Land at Climping, West Sussex

Transport Statement

i-Transport Ref: TW/BB/ITB16079-002F

Date: 13 June 2023

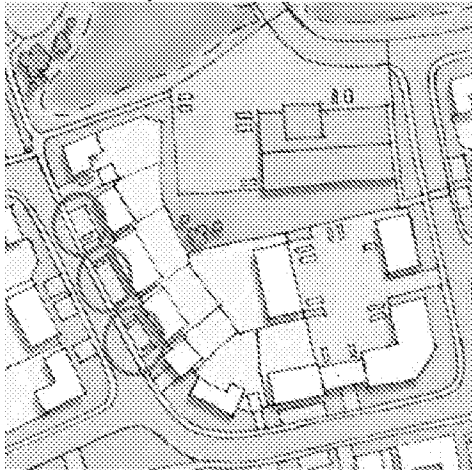
- *It should be confirmed if the road highlighted below has at least one footway abutting the carriageway unless there is a specific planning requirement/feature which requires a verge between the carriageway and footway.*

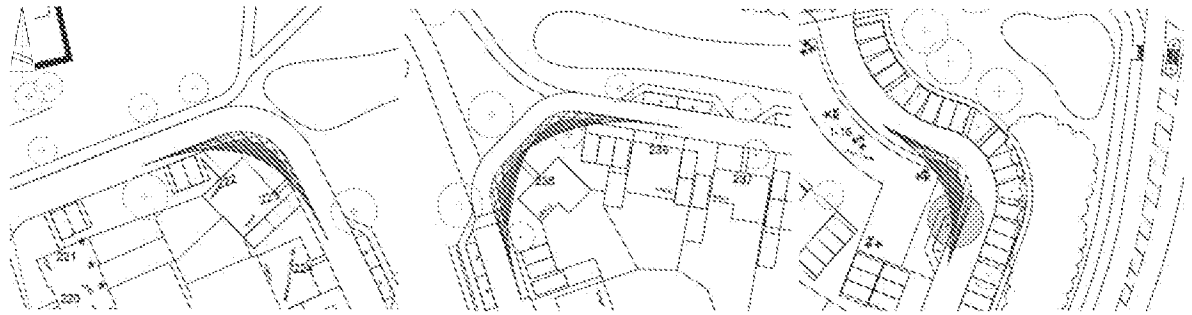
- 2.6 The terms of reference of this Road Safety Audit are as described in GG119. The scheme has been examined and this report compiled, only with regard to the safety implications for road users of the scheme as presented. It has not been examined or verified for compliance with any other standards or criteria. However, in order to clearly explain a safety problem or the recommendation to resolve a problem, the Audit Team may on occasion have referred to a design standard for information only. All comments and recommendations are referenced to the design drawings supplied with the Audit Brief and the location of road safety concerns raised have been illustrated beneath the items along with relevant photographs for clarity, where appropriate, as well as on the Location Plan attached at **Appendix A2**.

DESIGN ORGANISATION RESPONSE provided by i-Transport on the 15 th March 2022 following formal issue of this Stage 1 Road Safety Audit on the 14 th March 2022	
Agreed -- a covenant will be placed on the affected properties requiring that any planting must be maintained below 600m to ensure the visibility envelopes can be achieved.	
AUDITOR'S VIEW OF DESIGN ORGANISATION RESPONSE dated 15th March 2022	
Confirmation that visibility will be maintained clear of obstructions, addresses the road safety concern at this stage.	
A.2	GENERAL
	No Road Safety Concerns in GENERAL have been raised at this stage
A.3	JUNCTIONS
A.3.1	PROBLEM
Location:	Scheme
Summary:	Visibility extends across land outside the proposed highway
Acc Type:	Vehicle side impact collisions
The proposals associated with this Stage 1 Road Safety Audit, includes general carriageways with footways as well as shared surface areas that are to be provided within a residential development of 300 dwellings that each accommodate off-street parking, be it within driveways or parking courts. The scheme drawings provided with the Audit Brief, illustrate that 25 metre visibility splays are achievable where carriageways meet in accordance with the stopping sight distance of approaching vehicles travelling at 20mph. The presence of speed control bends and traffic calming measures in the form of raised tables and shared surface areas should ensure vehicular speeds are maintained low and that the achievable visibility is adequate. However, the visibility splays illustrated at many of the driveways and entrances to the parking courts, to include in proximity to the local shops and nursery, pass over land that is assumed to be outside the public highway. Should vegetation be planted and permitted to grow within the areas, visibility to and from approaching vehicles could be limited which may lead to a vehicle attempting to exit a priority access when it is not safe to do so, into the path of an oncoming vehicle and lead to side impact collisions.

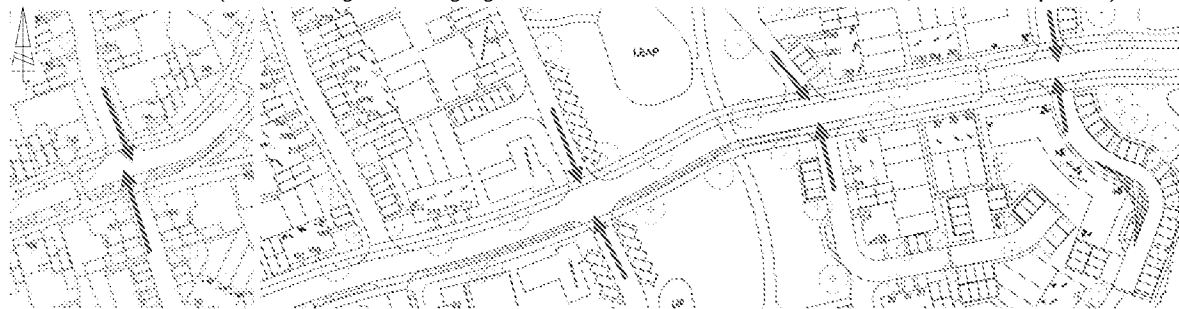
RECOMMENDATION:	
It is recommended that a sufficient level of visibility is achievable at all times	
Location Plan: (NB: The image below highlights three locations where this item is relevant, more are be present)

DESIGN ORGANISATION RESPONSE provided by i-Transport on the 15 th March 2022 following formal issue of this Stage 1 Road Safety Audit on the 14 th March 2022	
Agreed – A covenant will be placed on the affected properties requiring that any planting must be maintained to 600mm or below to ensure that visibility splays can be achieved.	
AUDITOR'S VIEW OF DESIGN ORGANISATION RESPONSE dated 15th March 2022	
Confirmation that visibility will be maintained clear of obstructions, addresses the road safety concern at this stage.	
A.3.2	PROBLEM
Location:	Scheme
Summary:	Priority may not be clear to drivers approaching junctions
Acc Type:	Vehicle side impact collisions
The proposals associated with this Stage 1 Road Safety Audit, includes general carriageways with footways as well as shared surface areas with a number of crossroad junctions generated. Vehicular speeds are expected to be low and priorities should be clear where surface treatments change, however, no such details have been provided at this stage and drivers will be able to see through the junction. There are concerns that traffic may approach the primary roads at inappropriate speeds and overshoot into the path of oncoming traffic or fail to give-way leading to side impact collisions

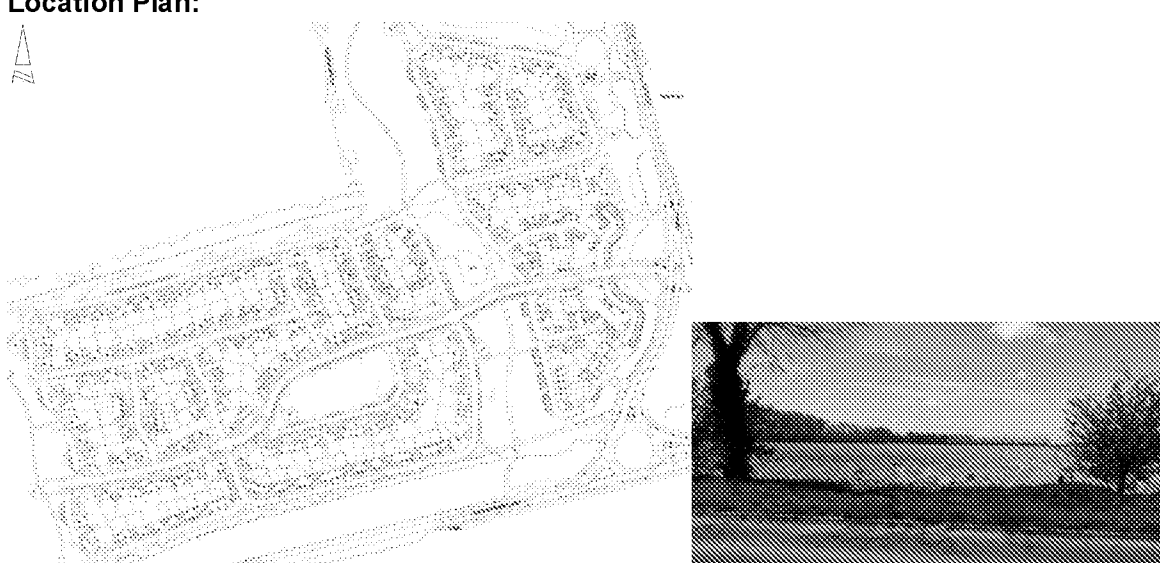
RECOMMENDATION:	
It is recommended that the point at which traffic must give-way is clear	
Location Plan: (NB: The image below highlights two locations where this item is relevant, more are to be present) 	
DESIGN ORGANISATION RESPONSE provided by i-Transport on the 15 th March 2022 following formal issue of this Stage 1 Road Safety Audit on the 14 th March 2022	
Agreed – Road markings will be provided at priority junctions with the primary roads and at the entrance to / exit from the parking facility associated with the proposed local shops.	
AUDITOR'S VIEW OF DESIGN ORGANISATION RESPONSE dated 15th March 2022	
Confirmation that road markings will be provided where appropriate, addresses the road safety concern at this stage.

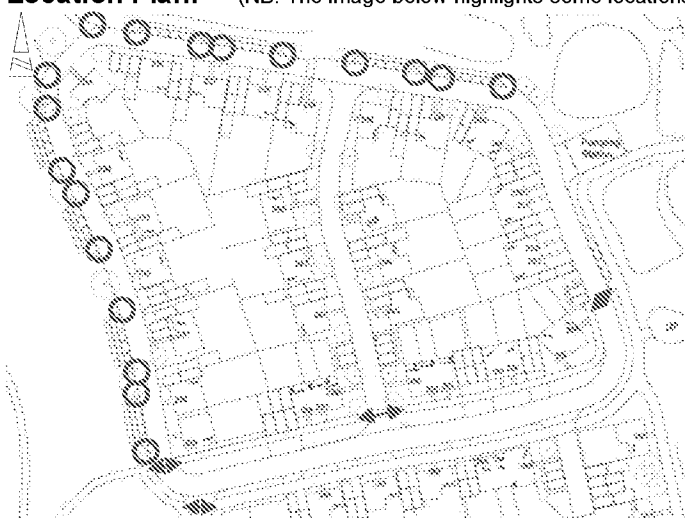
A.4	WALKING CYCLING AND HORSE RIDING
A.4.1	PROBLEM
Location:	Scheme
Summary:	Pedestrians may not be seen during the hours of darkness
Acc Type:	Vehicle pedestrian collision
The scheme drawing provided with the Audit Brief, illustrate that the proposed on-site highway is to consist of 4.8 and 6 metre wide carriageways as well as shared surface areas. At this stage, the Audit Team is unaware if the proposals are to be subject to street lighting. Whilst vehicles are driven during the hours of darkness with head lights illuminated, drivers may not become aware of the presence of pedestrians at a safe distance leading to vehicle pedestrian collisions.	
RECOMMENDATION:	
It is recommended that a level of street lighting is provided particularly in proximity to where pedestrians can be expected to cross or enter the carriageway and within the shared surface areas.	
Location Plan: 	
DESIGN ORGANISATION RESPONSE provided by i-Transport on the 15th March 2022 following formal issue of this Stage 1 Road Safety Audit on the 14th March 2022

Agreed - this will be dealt with at the detailed design stage.	
AUDITOR'S VIEW OF DESIGN ORGANISATION RESPONSE dated 15th March 2022	
Confirmation that this item will be considered during detail design, addresses the road safety concern raised at this stage.

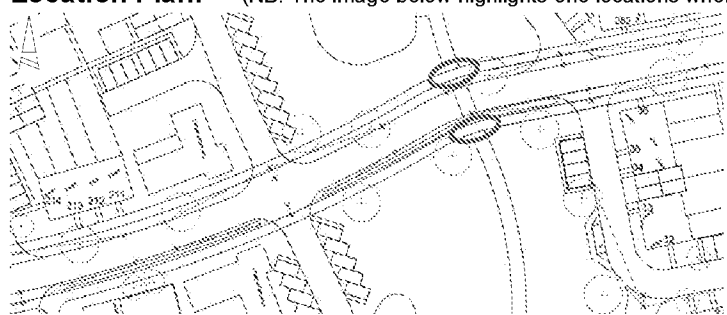
A.4.2	PROBLEM
Location:	Scheme
Summary:	Full height kerbs will be an obstruction to non-motorised users
Acc Type:	Trip / fall and personal injury, vehicle pedestrian collisions
The scheme drawing provided with the Audit Brief, identifies that the proposed development is to consist of general carriageways with footways as well as raised shared surface areas with direct accesses to pathways to properties and footpath / cyclepath links. At this stage no details have been provided to identify the proposed edge treatment around the shared surface areas. Kerbing in excess of 6mm is a trip hazard for pedestrians, those with perambulators, the mobility impaired and cyclists which could lead to falls and personal injury. Further, visually impaired pedestrians could enter a live carriageway into the path of a vehicle unaware leading to a vehicle pedestrian collision	
RECOMMENDATION:	
It is recommended that level access is provided with tactile paving where appropriate along non-motorised user desire lines.

Location Plan: (NB: The image below highlights some locations where this item is relevant, more are present) 	
DESIGN ORGANISATION RESPONSE provided by I-Transport on the 15th March 2022 following formal issue of this Stage 1 Road Safety Audit on the 14th March 2022	
Agreed - Desire lines will be assessed during the detail design of the scheme with dropped kerbs and tactile paving provided where necessary.	
AUDITOR'S VIEW OF DESIGN ORGANISATION RESPONSE dated 15th March 2022	
Confirmation that dropped kerbs and tactile paving will be provided, addresses the road safety concern raised at this stage.

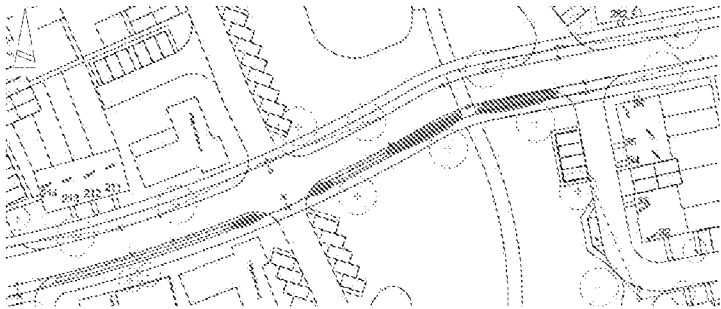
A.4.3	PROBLEM
Location:	Southern side of primary spine road
Summary:	No warning is provided to highlight the change in characteristics of the footways
Acc Type:	Vehicle pedestrian collisions
The proposals include the provision of numerous footways as well as shared surface areas and footpaths / cyclepaths through the open space within the application site. The Audit Team have concerns that pedestrians travelling from a footway will step onto a shared area without warning that cyclists or vehicular traffic could be present. A pedestrian not becoming aware that they are entering a shared area where cyclists or motorists could be present, may step into their path leading to a vehicle / cyclist collision with a pedestrian.	
RECOMMENDATION:	
It is recommended that corduroy / hazard warning tactile paving is provided where the characteristics of the surface change	
Location Plan: (NB: The image below highlights one locations where this item is relevant, more are present)

DESIGN ORGANISATION RESPONSE provided by I-Transport on the 15th March 2022 following formal issue of this Stage 1 Road Safety Audit on the 14th March 2022	
Agreed -- Corduroy paving will be provided where necessary, this will be dealt with at the detailed design stage.	
AUDITOR'S VIEW OF DESIGN ORGANISATION RESPONSE dated 15th March 2022	
Confirmation that tactile paving will be provided where appropriate, addresses the road safety concern raised at this stage.	
A.4.4	PROBLEM
Location:	Southern side of primary spine road
Summary:	Hedges could grow to limit visibility to and from a non-motorised user
Acc Type:	Vehicle pedestrian collisions
The proposals include the provision of numerous footpaths / cyclepaths through the proposed development area as well as footways besides the proposed on-site carriageways. The site layout plan provided with the Audit Brief, illustrates what is believed to be hedges to the south of the primary spine road and either side of where the proposed footpaths meet the carriageway. No landscaping details have been provided at this stage. Should the planting be permitted to grow higher than 600mm there is a risk that insufficient intervisibility will be available. Recent updates

to the Highway Code have introduced pedestrian and cyclist priorities over vehicular traffic and therefore drivers are required to stop and to allow non-motorised users to cross side roads, however, limited visibility could result to the users not becoming aware of one another at a safe distance leading to vehicle non-motorised user collisions	
RECOMMENDATION:	
It is recommended that no foliage is planted within pedestrian visibility slays to ensure clear visibility is maintained at all times	
Location Plan: (NB: The image below highlights two locations where this item is relevant, more are present) 	
DESIGN ORGANISATION RESPONSE provided by I-Transport on the 15 th March 2022 following formal issue of this Stage 1 Road Safety Audit on the 14 th March 2022	
Agreed – this will be dealt with at the detailed design stage.	
AUDITOR'S VIEW OF DESIGN ORGANISATION RESPONSE dated 15th March 2022	
Confirmation that this road safety concern will be further considered during the detail design of the scheme, addresses the road safety concern raised at this stage.
